RB290-22

IRC: AF103.6.1

2021 International Residential Code

FIGURE AF101.1 EPA MAP OF RADON ZONES

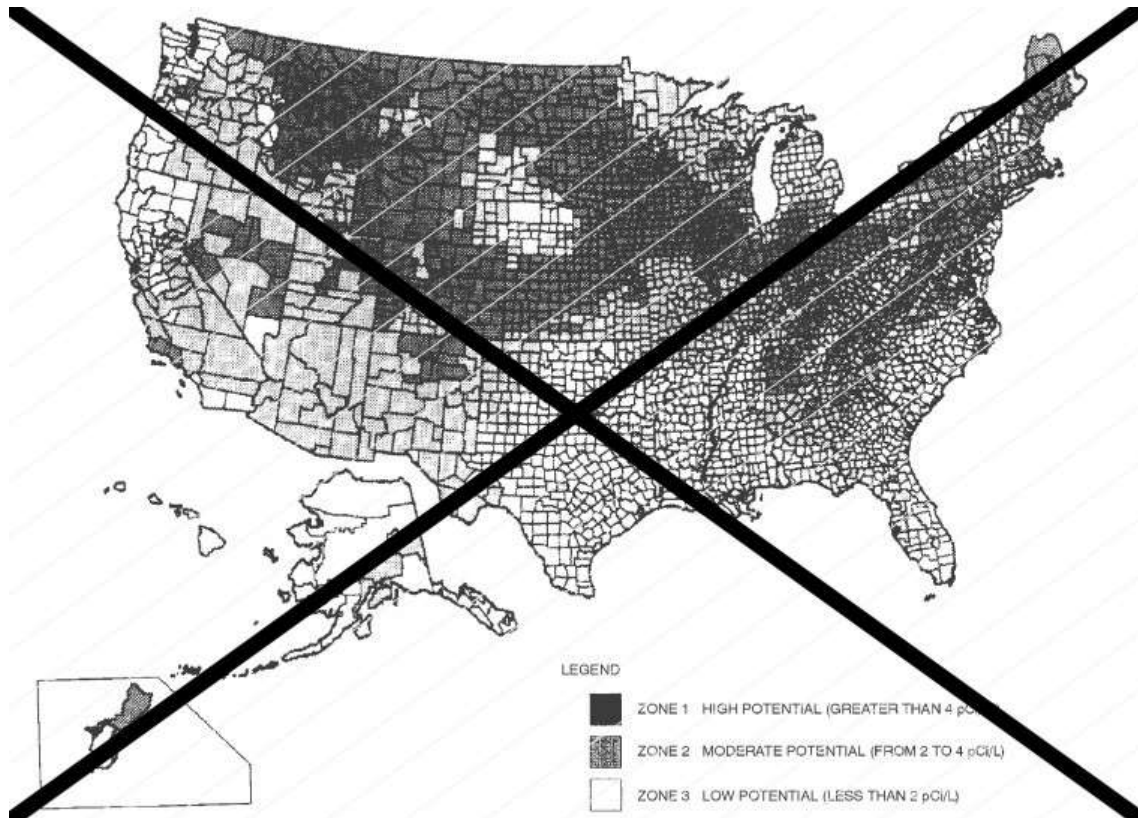
AF101.1 General. This appendix contains requirements for new construction in ~~jurisdictions~~ where radon-resistant construction is required. Inclusion of this appendix by ~~jurisdictions~~ shall be determined through the use of locally available data or determination of Zone 1 designation in Figure AF101.1 and Table AF101.1.

Delete without substitution:

- a. ~~The EPA recommends that this county listing be supplemented with other available state and local data to further understand the radon potential of a Zone 1 area.~~

Reason Statement: The EPA map and Zone 1 county list are based in part on a 1993 survey that measured radon in 5694 homes, less than two per each of the 3141 counties in the US. As more recent data have been compiled by states and the US Centers for Disease Control and Prevention, it is evident that more counties' average radon test results equal or exceed the EPA action level.

In response to stakeholder feedback EPA has been deemphasizing the use of the EPA zone map as a reference for building codes and specifications. The purpose of the EPA radon zone map, since its inception, has been to show potential of risk not ACTUAL risk. While it is still a useful tool, it unintentionally creates a false sense of security for those in Zone 2 and Zone 3 that risk in those areas is non-existent. With this in mind, the EPA Indoor airPLUS program (a voluntary partnership and labeling program that helps new home builders improve the Indoor Air Quality) plans to include testing in ALL ZONES in its upcoming Version 2 update. The fact remains that radon is found in all zones and to truly protect against radon you need to test regardless of zone.
